Review of groundwater chapter of SA DEM assessment of the Terramin Bird in Hand MLA

28 January 2022

The South Australian Department of Energy and Mining (DEM) engaged CSIRO to review the groundwater chapter of the government assessment of the Terramin Bird in Hand Gold Mine Lease Application (MLA). DEM provided a draft version of the groundwater chapter on 08/11/21 together with the documents the assessment is based on. On 07/12/21, an additional document, the Terramin response to DEM's letter dated 20 October 2021, was provided. On 15/12/21, an updated draft of the groundwater chapter was provided, in which the section on controlled inundation was updated. This document will be referred to as DEM groundwater advice (2021).

Figure 1 Parameter zonation in Layer 5 (Fig. 25 in Appendix B7A)

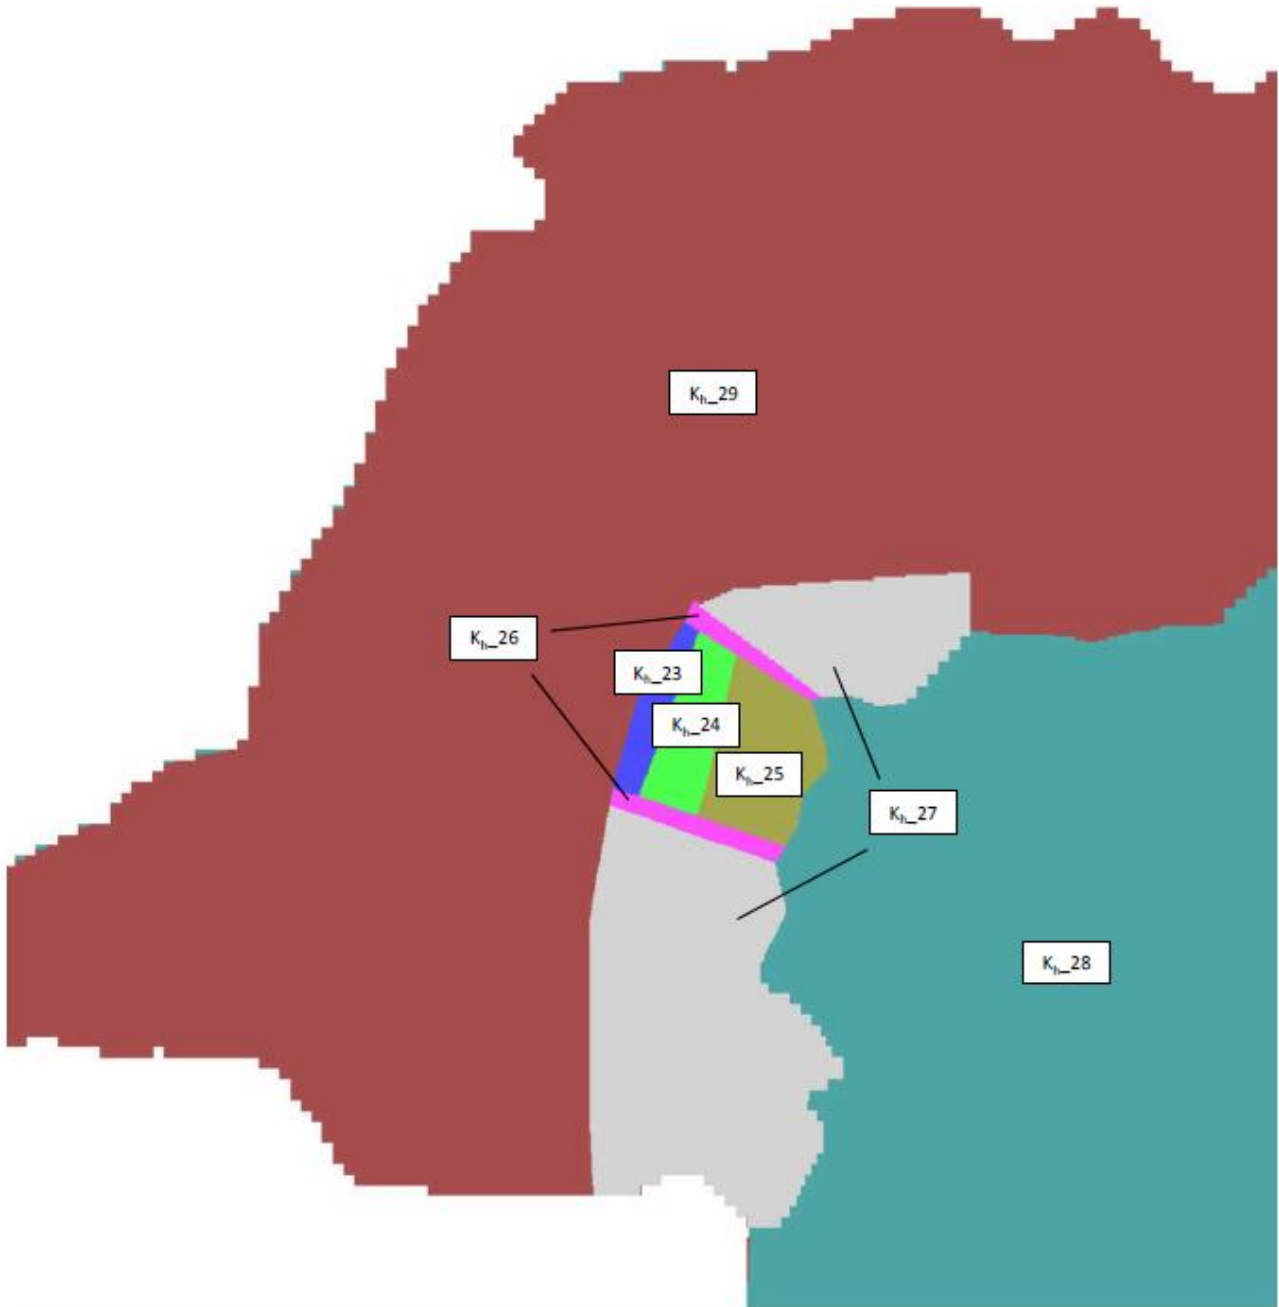
Consider the area in which the mine stopes will be developed in layer 5, which comprises parameter zones Kh_23 and Kh_24 (Figure 1). The equivalent K for this area (assuming zones have similar length and flow is perpendicular to the longest side of each K-zone) is:

The posterior distribution after rejection sampling is very similar to the prior distribution for both parameter zones, with a standard deviation that is designed to cover 2 orders of magnitude (0.67 of log₁₀ K). Figure 2 shows the equivalent log₁₀ hydraulic conductivity distribution calculated using Eq. 2 for 10,000 random samples drawn from the normal distribution with mean and standard deviation for Kh_23 and Kh_24 taken from the prior values in table 7 in Appendix B7A.

Figure 5 Conceptual hydrogeological cross section (Fig F3 in Appendix H1)

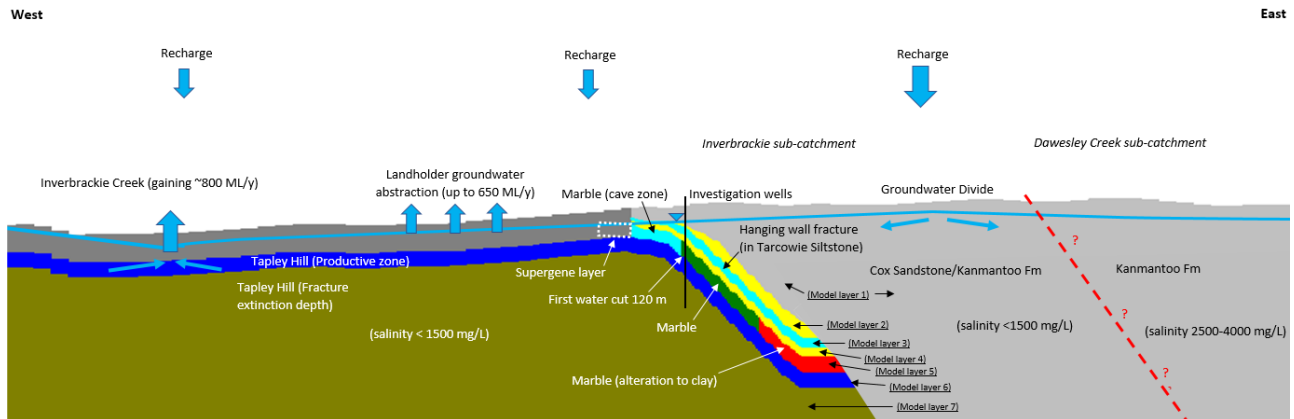
The MLA is in a fractured rock aquifer, where hydraulic parameters are dominated by the secondary permeability (faults and fractures) with less influence of lithology. The hydrostratigraphic units in the hydrogeological conceptualisation do largely follow stratigraphy (Figure 5). This is consistent with the information presented in the groundwater assessment reports.

Figure 6 Model discretisation and layering (Fig. F4 in Appendix H1)

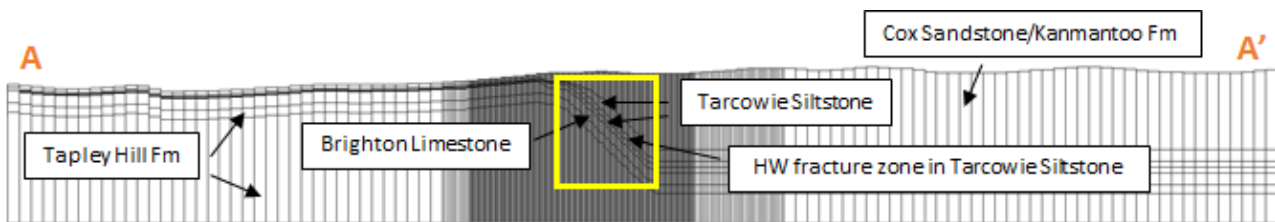
Figure 6 shows how this conceptualisation of hydrostratigraphic units is translated in the discretisation and layering of the numerical model. Hydrostratigraphic units are largely represented as individual layers. The layers in the vicinity of the fault zone and the mineralisation are steeply dipping. This creates following issues:

1. Horizontal and vertical conductivity in the model represent flow along and perpendicular to the dip of the model layer. Lateral flow is a combination horizontal and vertical conductivity. This makes it almost intractable to infer from the model report which parameters are controlling mine water inflow and whether this represents an adequate representation of the conceptualisation.
2. Layers 1-5 are very thin and unsaturated in the west of the model. This makes that:
 - a. Hydraulic parameters assigned to zones in the west of the model are irrelevant (they are excluded from the calculations)
 - b. Lateral drawdown in layer 5, which hosts the drainage features for mine stopes, cannot directly propagate to the west. The drawdown can only propagate westwards by propagating downward into layer 6.

- c. The watertable is hosted in layer 6 in the west and layer 1 in the east. The report¹² does not show which layers are simulated as confined or unconfined where in the model. This can have a large impact on simulated results as the storativity in unconfined layers is up to four orders of magnitude larger than storativity in confined layers.

Rapid changes in geometry and thin, unsaturated layers are known to deteriorate the numerical stability of a numerical model. While this does not seem to affect the calibrated model, the rejection sampling illustrates that especially the transient model is not very robust, with a large number of model runs failing to meet the water balance error target. As discussed earlier, this can affect the estimation of the 95th percentile of mine inflows.

The complexity of the layer structure makes the model less transparent and tractable. An alternative layer structure would be to use horizontal layers with uniform thickness and represent the hydrostratigraphic units through different parameter zones.
